DOCKET ITEM #5
Development Special Use Permit #2019-0021
Special Use Permit #2019-0090
Special Use Permit #2019-0091
Modera Tempo Amendment

Application	General Data	
Project Name: Modera Tempo (Amending DSUP #2011-0030) Location: 650 South Van Dorn Street Applicant: Mill Creek Residential Trust, LLC, represented by Ken Wire, Esq., WireGill	PC Hearing:	November 7, 2019
	CC Hearing:	November 16, 2019
	If approved, DSUP expiration:	November 16, 2022 (36 months)
	Plan Acreage:	6.31 Acres
	Zone:	CDD #17
	Proposed Use:	Residential & Commercial Retail
	Dwelling Units:	492
	Gross Floor Area:	549,890 sf (15,000 sf retail)
	Small Area Plan:	Landmark/Van Dorn
	Green Building:	Complying with the Green Building Policy

The applicant requests an amendment to DSUP# 2011-0030 to approve Development Special Use Permit #2019-0021, with modifications, to reallocate residential parking spaces in the garage for commercial/retail uses and associated Special Use Permits for a parking reduction to permit more than 30% compact commercial parking spaces (SUP #2019-0090) and to exceed the maximum number of off-street commercial parking spaces (SUP #2019-0091).

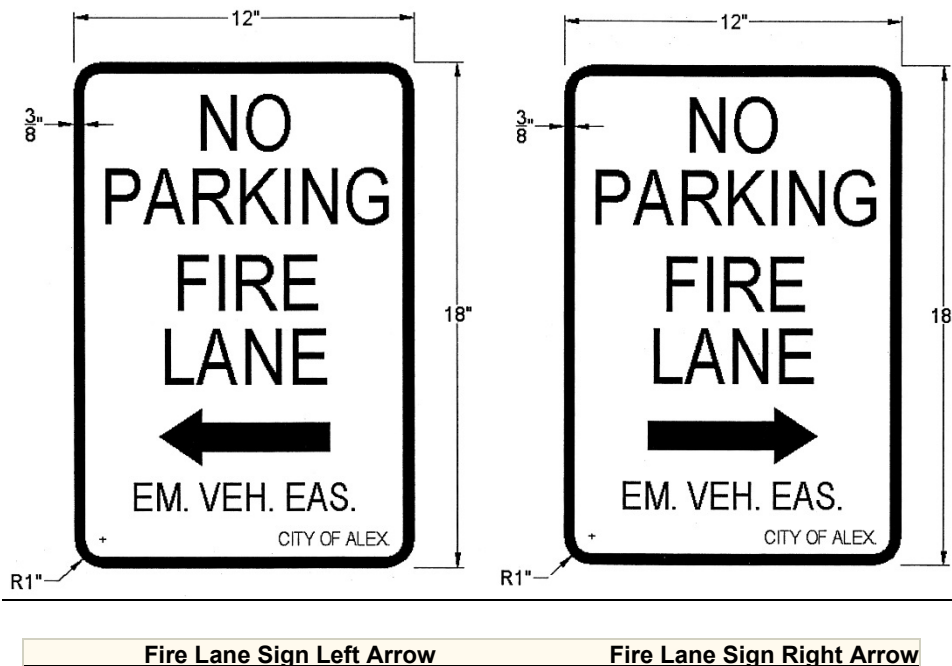
- C-7 The final site plans shall show placement of emergency vehicle easement signs. See sign detail and placement requirements below. Current plans do not have correct signage.

Figure 1020.1.6.2 Example Building Footprint Sign

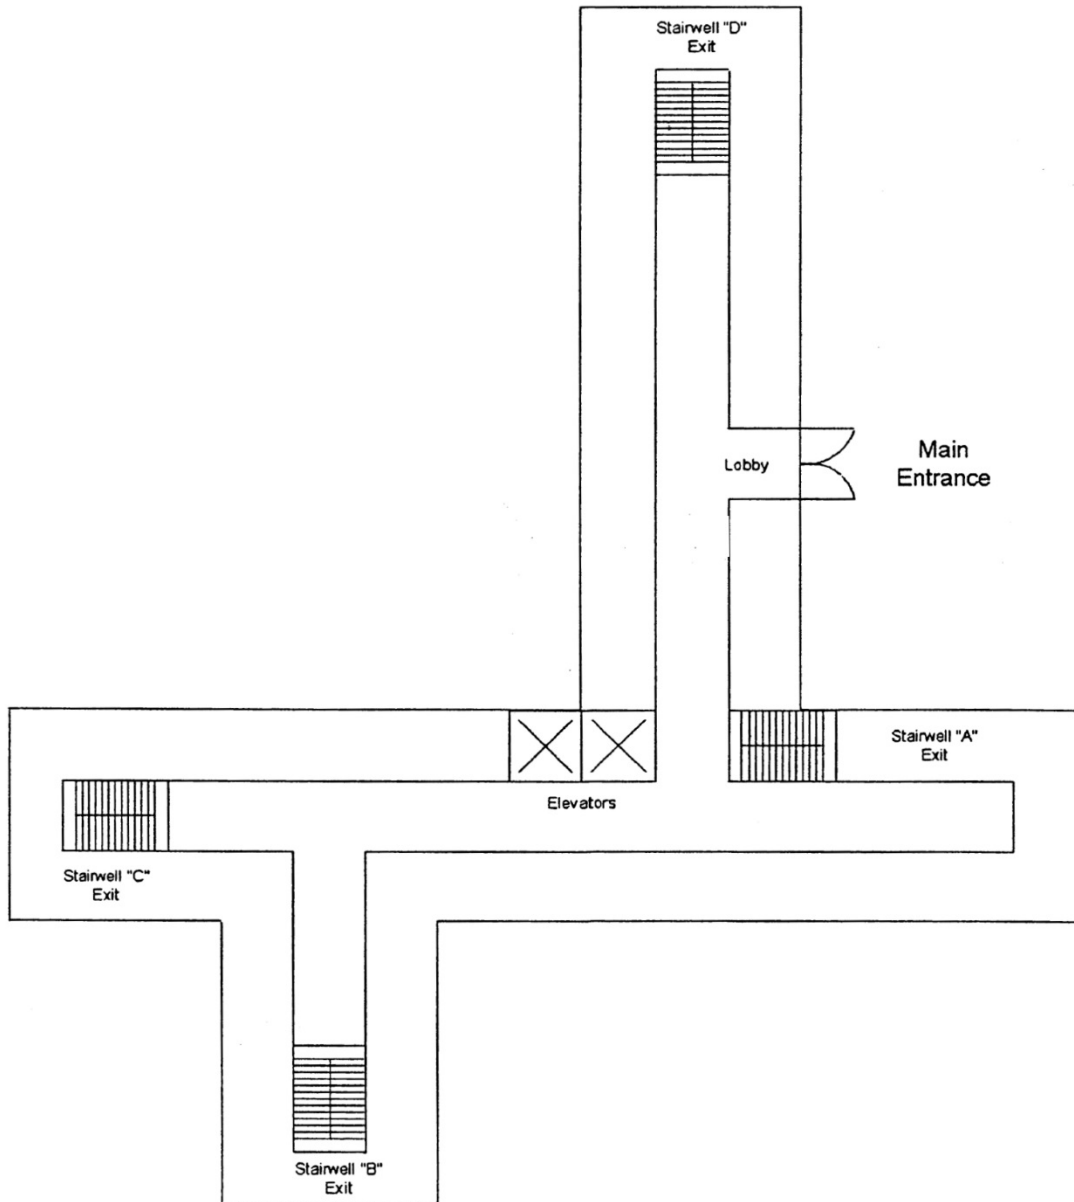
- C-9 Provide Stairway Identification. A sign shall be provided at each floor landing in interior vertical exit enclosures connecting more than three stories designating the floor level, the terminus of the top and bottom of the stair enclosure and the identification of the stair. The signage shall also state the story of, and the direction to the exit discharge and the availability of roof access from the stairway for the fire Department.

Footprint requirements. In buildings greater than three stories where there is no graphic representation of the building footprint, a simplified building schematic must be display in the lobby. The simplified building footprint shall be an overhead view of the buildings exterior and the general layout of the lobby of the first floor. Stairways shall be denoted by letter as stated in section 1020.1.6. (See Figure 1020.1.6.2)
